DESCRIPTIVE REPORT

DESCRIPTIVE REPORT TO ACCOMPANY HYDROGRAPHIC SHEET FIELD NUMBER 2,
1934, 35, WESTERN END OF SANTA ROSA SOUND, FLORIDA, PROJECT H. & T.
NUMBER 196.

REVIEW OF HYDROGRAPHIC SURVEY NO. 5668 (1934-35)

Subject: H 5668, Santa Rosa Sound, West Entrance, Florida.

Tracing #1

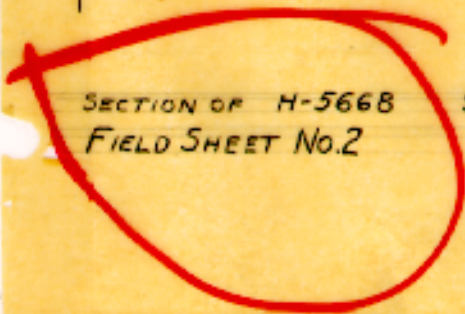
- f. At position 61 FF, page 24 of Volume 11 (lat. $36^{\circ}22.4'$, long. $87^{\circ}05.4'$), a note in the "Remarks" column appears thus: "Passed outside old dock and inside lone piling." The dock was not shown on the boat sheet nor on the smooth sheet and is not shown on the air photo compilation. A sketch of the area has been sent to the field party to add the location of the dock.

Two tracings of sections of H 5668 (field sheet No. 2), Santa Rosa Sound, West Entrance, Florida, are inclosed. Tracing No. 1 shows position 61 FF where the note "Passed outside old dock and inside lone piling" occurs in the sounding records. The dock was not shown on the boat sheet, the smooth sheet, nor the air photo compilation. Please indicate on the sketch the position of this dock.

Note in sounding record:
"passed outside old dock and
inside lone piling"

Ruins of old dock here now shown as indicated by tracing & letter from Chief of Party. see letter June 21, 1935 attached from Chief of Party.

On tracing # 1, the dock referred to is shown in pencil in its approximately correct position. For your information all that is left of this dock is the dilapidated piling.
